TR 2022-32 –Change in Valve Spacing Due to Class Change

Section 192.610

TR 2022-32 –Change in Valve Spacing Due to Class Change

Figure 192.610A

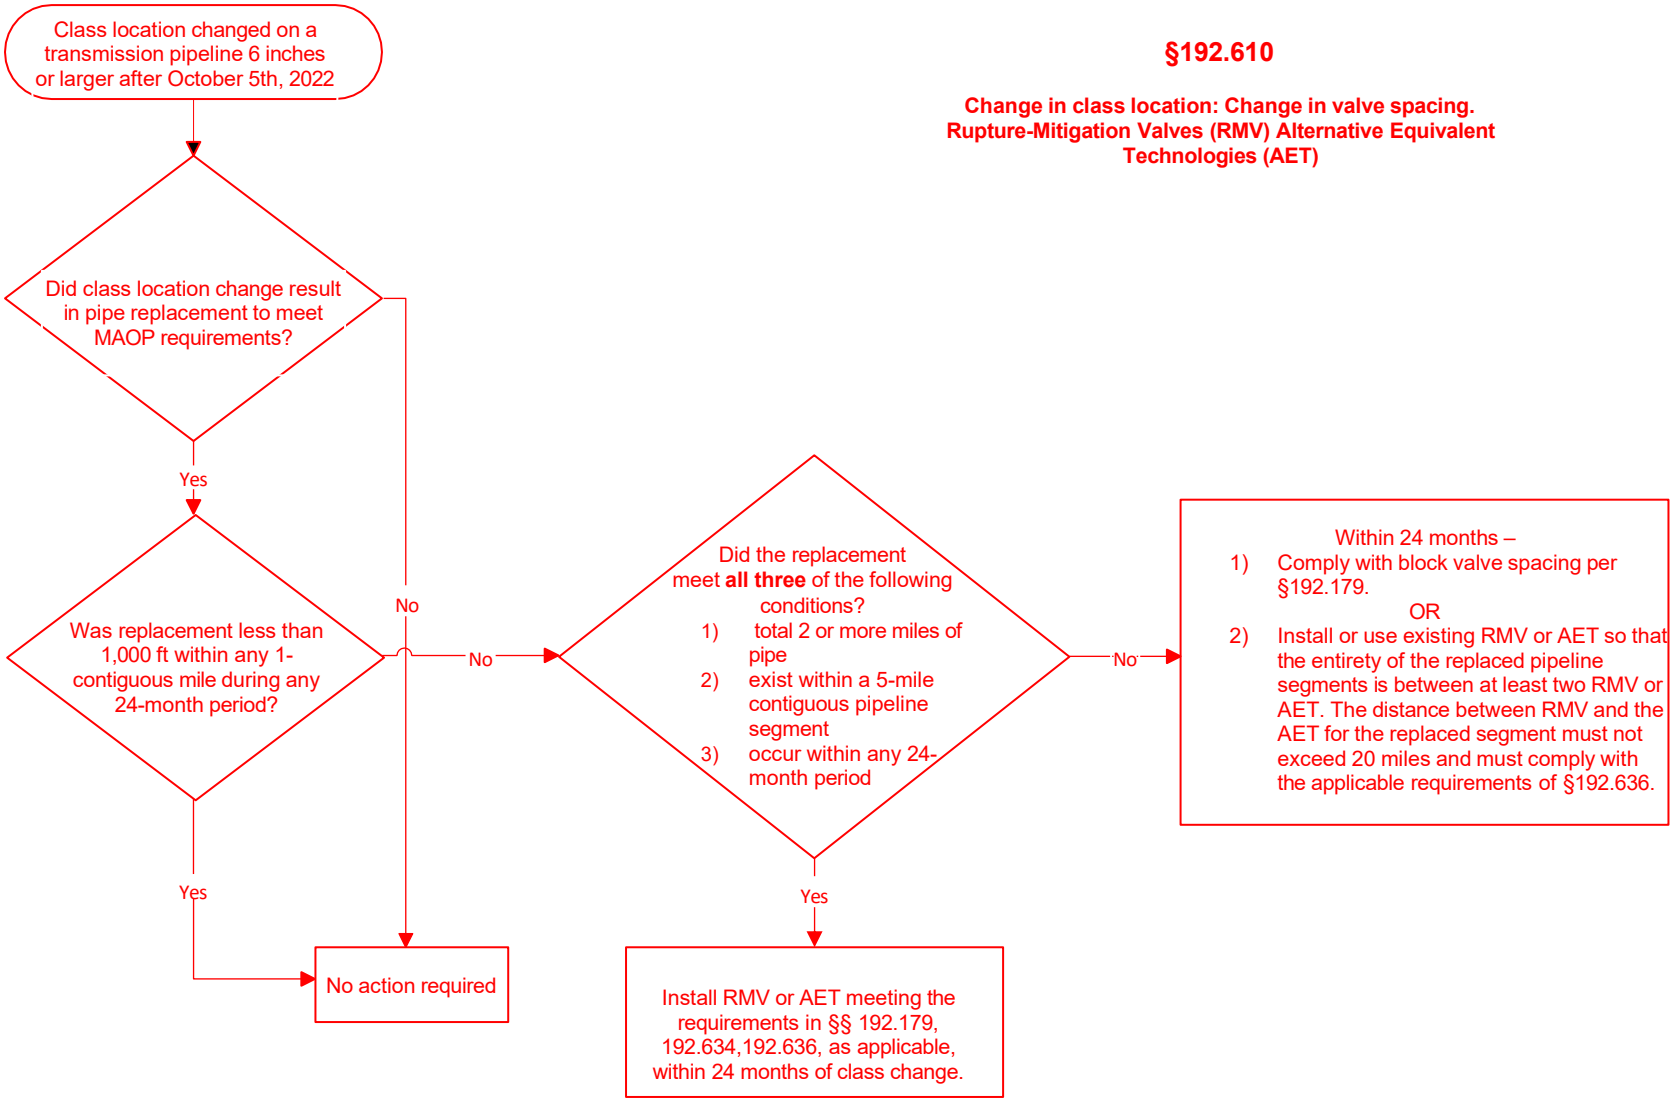
The following flowchart is to assist operators in determining the additional requirements due to a class location change on a transmission pipeline 6 inches in diameter or larger.

Change in class location: Change in valve spacing. Rupture-Mitigation Valves (RMV) Alternative Equivalent Technologies (AET)
